Government of the District of Columbia

Department of Transportation

MEMORANDUM

SUBJECT: ZC Case No. 21-09 – 899, 901, 999 North Capitol Street NE (Union Square)

Figure 5 | Existing Pedestrian Network

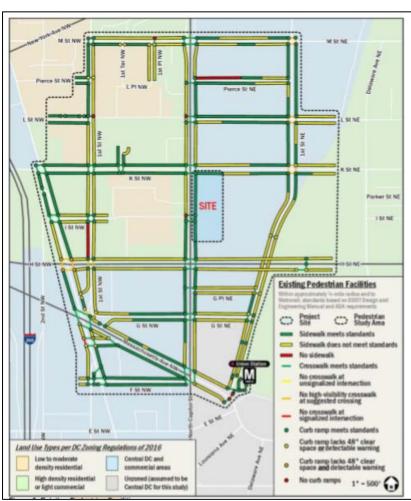
The Applicant's inventory of existing pedestrian infrastructure, as shown in Figure 5 below, demonstrates that most sidewalks in the immediate vicinity of the site are currently constructed with appropriate widths and include accessible curb ramps. In particular, there is a missing ADA ramp on the west side of North Capitol Street where it intersects with I Street NW and the proposed hotel. Given the existing high parking ratio and new retail and hotel uses, the Applicant should include the construction of the ramp in their TDM Plan (see end of this report).

The project is subject to both the NoMa Streetscape Booklet and the North Capitol Streetscape Guidelines. Additionally, the sidewalk scoring along K Street NE and North Capitol Street must continue across the existing curb cuts to prioritize the pedestrian path and improve the pedestrian experience. DDOT notes that the final design of the streetscape, curb ramps, and crosswalks will occur during public space permitting.

- Add to TDM Plan: Prior to issuance of a Certificate of Occupancy associated with either Phase 1
 or Phase 2 development, whichever occurs first, the Applicant will fund and construct the
 missing ADA curb ramp on the west side of North Capitol Street on the northern side of the
 intersection with I Street NW, subject to DDOT approval.
- Add to TDM Plan: Future employees of the 901 N. Capitol Street NE building will be permitted and encouraged to use shared shower and locker facilities located in the 899 and 999 buildings.
- Add to TDM Plan: Applicant will implement a pick-up/drop-off plan in the 999 parking garage for the future 901 N. Capitol Street NE hotel if curbside signage on N. Capitol Street is not approved by DDOT. The contents of this pick-up/drop-off plan will be further discussed and finalized during public space permitting.
